RE: Seeley Reservoir Stockpiles, File No. # M-2023-043, New 112c Application, Adequacy Review-1

RE: Seeley Reservoir Stockpiles, File No. M-2023-043 (Adequacy Review/Additional Application Comments)

SEELEY RESERVOIR SEDIMENT BASIN CONSTRUCTION DRAWINGS

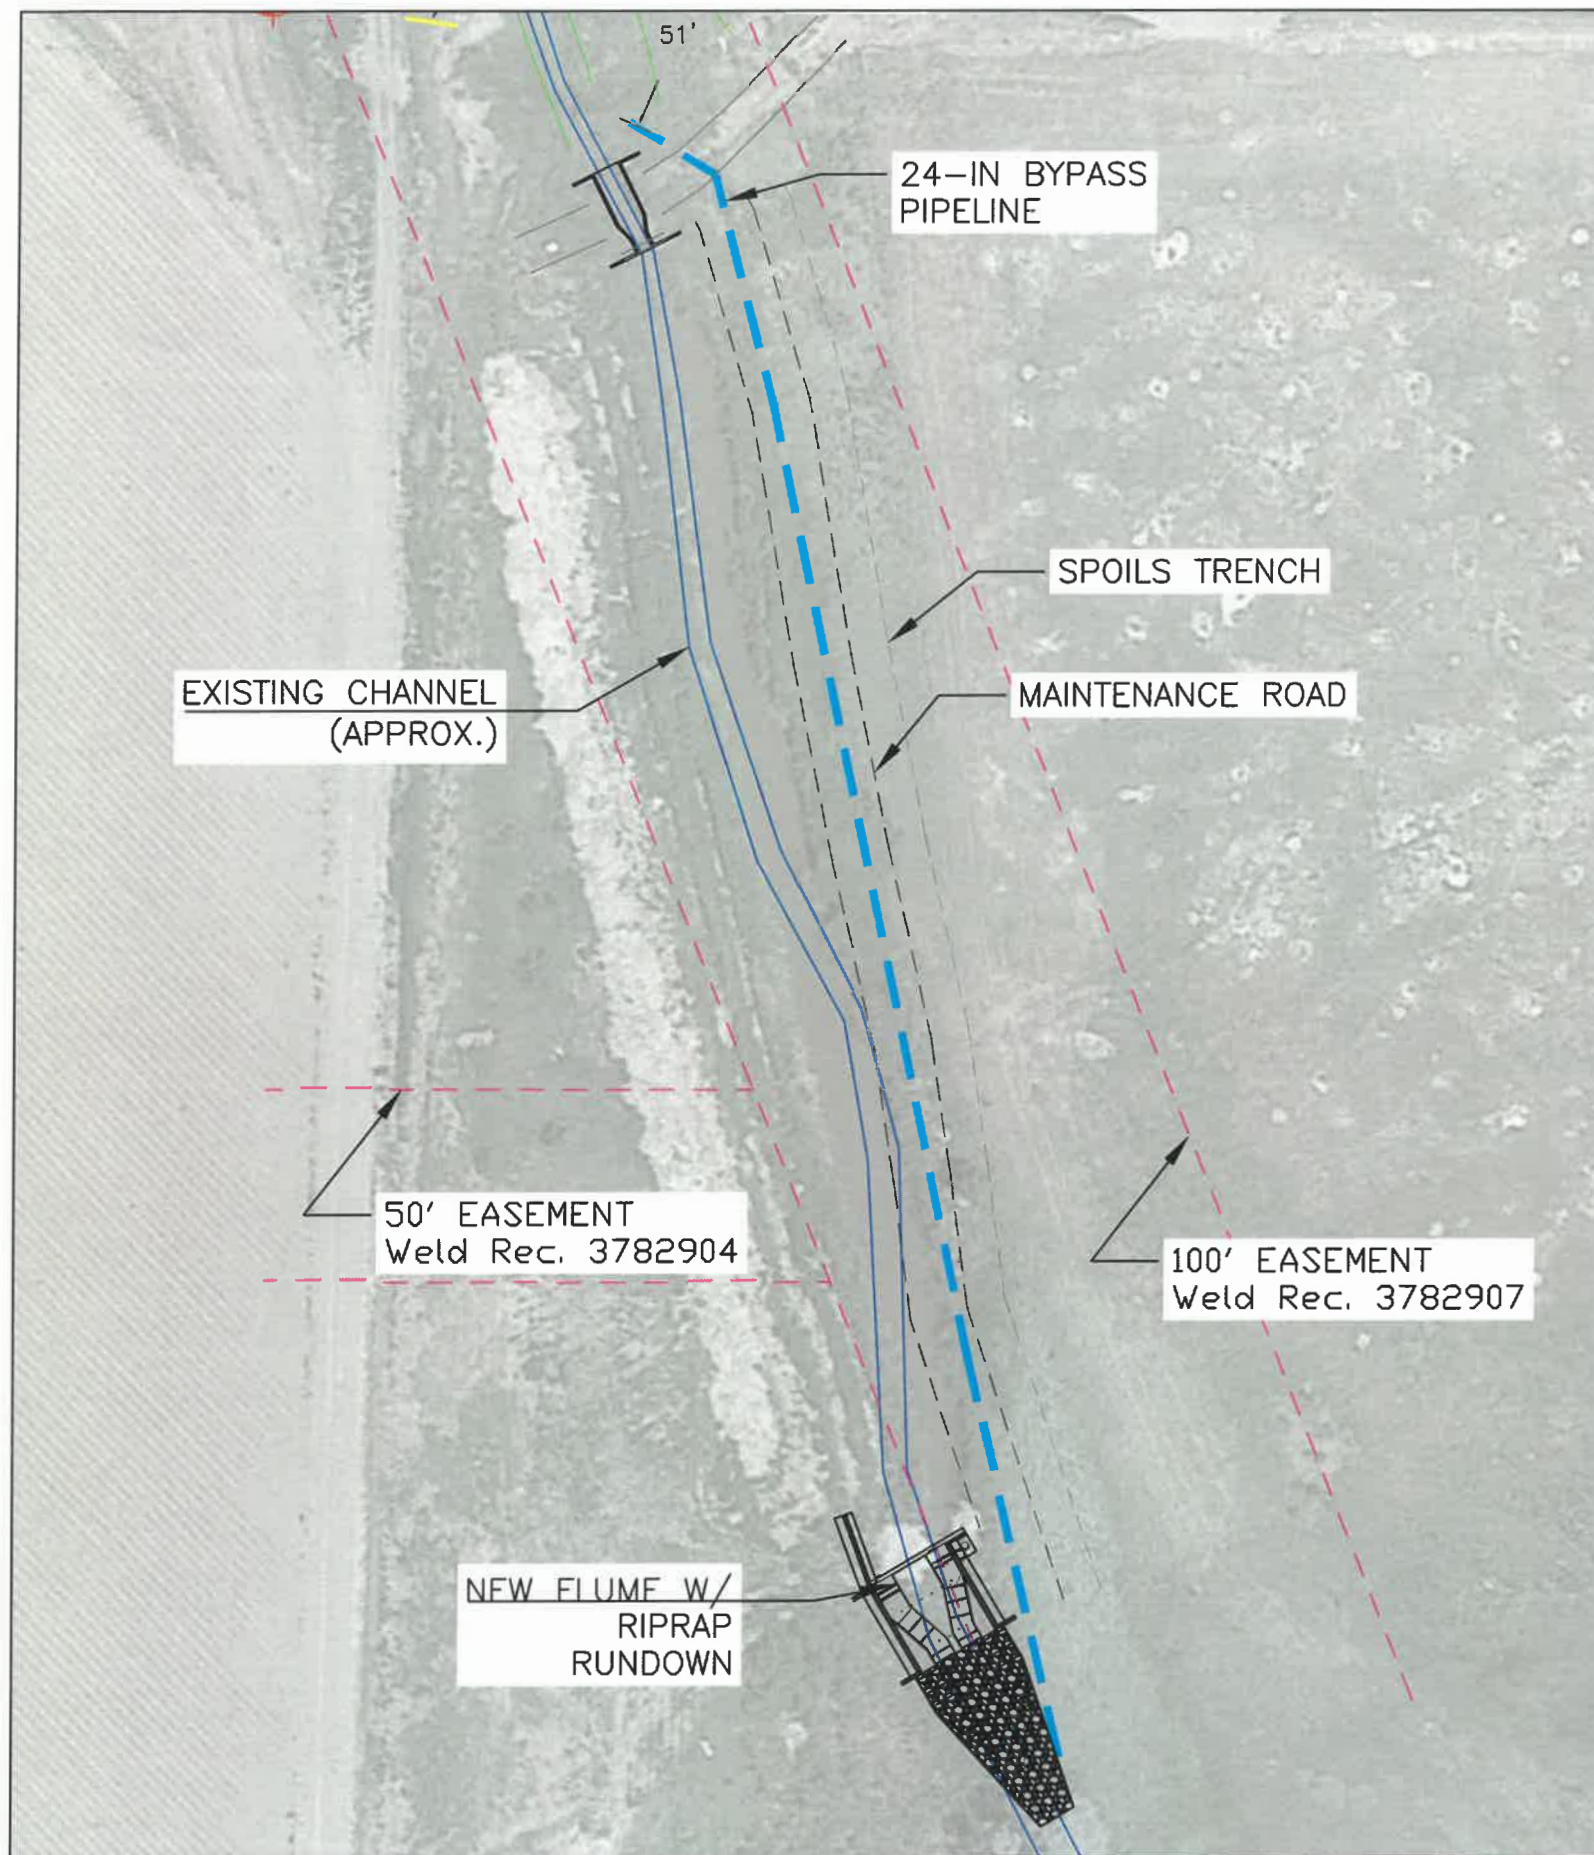
1. Please see the image below, highlighting an emergency spillway that would have a detrimental impact to our property and was built in conjunction with the structure impacting our properties. I have also included via "Attachment B" the retroactively stamped plans related to this structure/area of concern noted in previous comments.
